| Project | IEEE 802.16 Broadband Wireless Access Working Group < http://ieee802.org/16 > | |
| Title | BPSK Modulation for IEEE 802.16 WirelessMAN™ OFDM | |
| Re: | Supporting document for Letter Ballot #13 | |
| Purpose | Adoption | |

On page 411, Figure 197, add BPSK as follows to the set of constellation options:

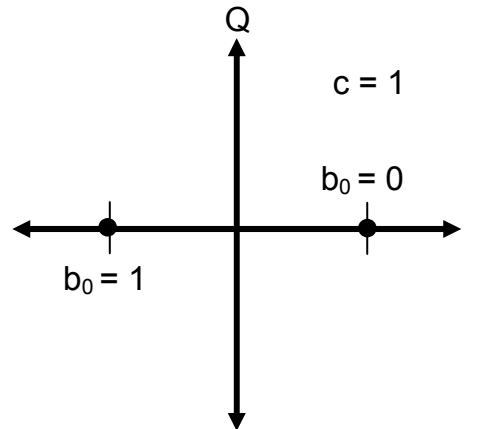
Also change the caption on Figure 197 accordingly and as follows:

”BPSK, QPSK, 16-QAM and 64-QAM constellations”
